Access Compliance Report

Public Rights-of-Way

Intersection ID: 49894	Main Street: ROCKY_FORD_CLUB_RD	Cross Street: RUTH_FERRELL_CT	Location: SW
ADA ID: B28A4B6FFA8D	Ramp Type: PerpDiag	Initial Pass/Fail: Fail	Overall Compliance: No
Severity Score: 21.25			
Codes/Mitigation Info/Possible Solution		Field Measurements/Component Compliance

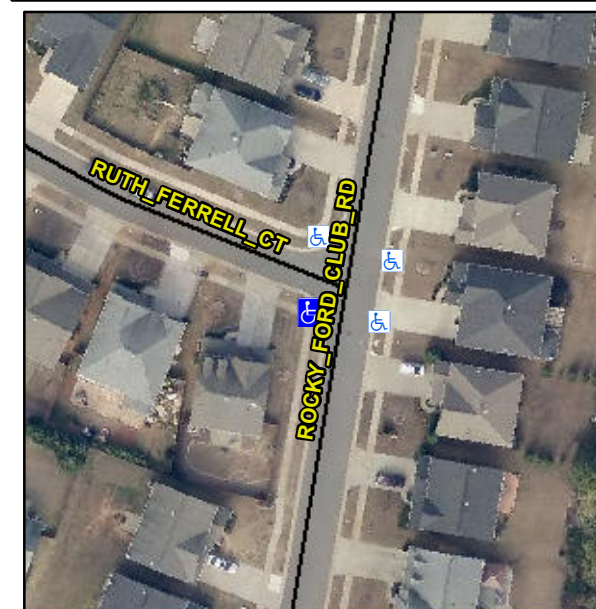
Not Found, R304.5.1, R304.5.3

Compliance	Description	Data	Compliance	Description	Data
N/A	Ramp Length (in)	71.0	Yes	Ramp Slope (%)	6.8
No	Ramp Width (in)	41.0	No	Ramp XSlope (%)	5.7
N/A	Flare Type LT	N/A	N/A	Flare Type RT	N/A
N/A	Flare Slope LT (%)	N/A	N/A	Flare Slope RT (%)	N/A
N/A	Flare Traversable LT?	N/A	N/A	Flare Traversable RT?	N/A
N/A	Landing Length (in)	N/A	N/A	DWS Provided?	N/A
N/A	Landing Width (in)	N/A	N/A	DWS Contrast?	N/A
N/A	Landing Slope (%)	N/A	N/A	DWS Length (in)	N/A
N/A	Landing X Slope (%)	N/A	N/A	DWS Full Width?	N/A
N/A	Landing Curb? (Y/N)	N/A	N/A	DWS Offset (in)	N/A
N/A	Shared Landing?	N/A			
N/A	Gutter Ponding?	N/A	N/A	Gutter Slope (%)	N/A
N/A	Gutter Lip Ht (in)	N/A	N/A	Gutter X Slope (%)	N/A
N/A	Painted X Walk1?	No	N/A	Painted X Walk2?	No
	X Walk 1 Direction	To E		X Walk 2 Direction	To N
N/A	X Walk 1 Width (in)	N/A	N/A	X Walk 2 Width (in)	N/A
	X Walk 1 Slope (%)	2.5		X Walk 2 Slope (%)	0.6
	X Walk 1 X Slope (%)	0.5		X Walk 2 X Slope (%)	2.7

Remove & Replace Curb Ramp With Two New Directional Ramps or Equivalent.
